**WEST BEACH DRIVE IMPROVEMENTS  
TOWNSHIP OF IGNACE**

**CONTRACT No. 17-2034**

**ADDENDUM #2  
August 28, 2017**

OPSD 803.030M

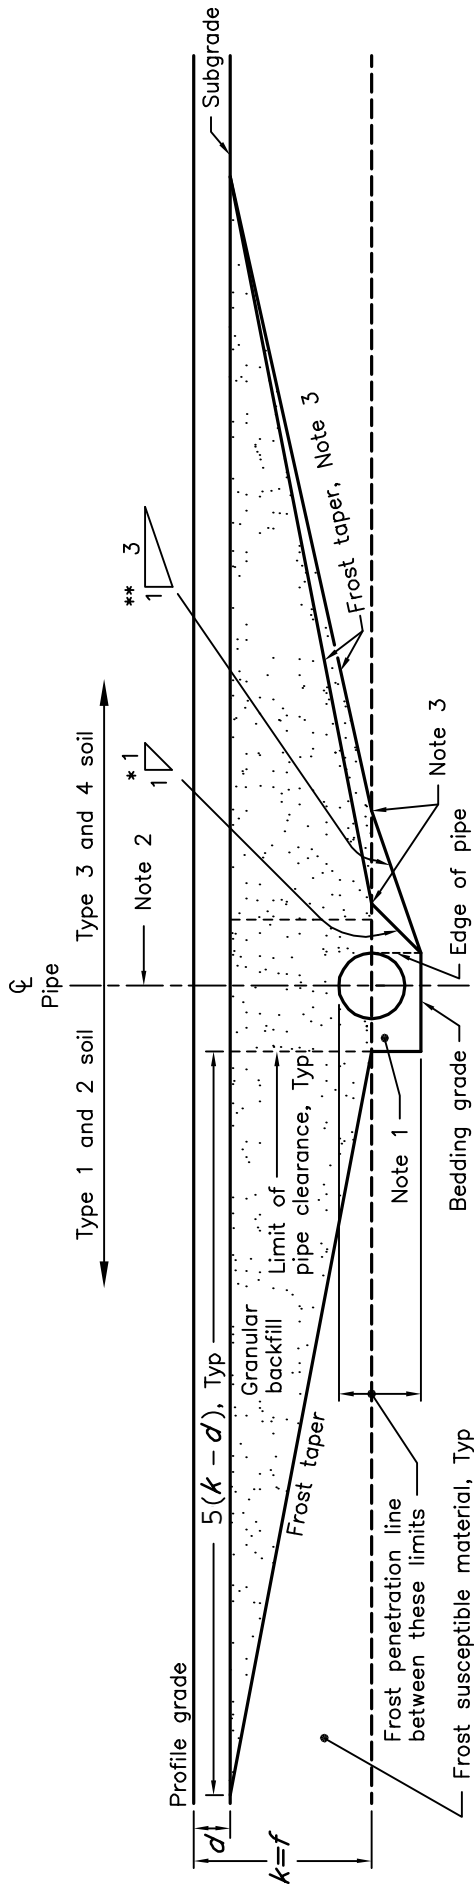
The Contractor shall construct frost tapers as per OPSD 803.030M and OPSD 803.031M (attached) for all centreline culvert replacements. Excavation and Granular Bedding shall be included in the unit price bid for the culvert installation. Granular "B" and Granular "A" embedment and backfill within 5:1 tapers shall be paid for under the Granular "B" and Granular "A" items.
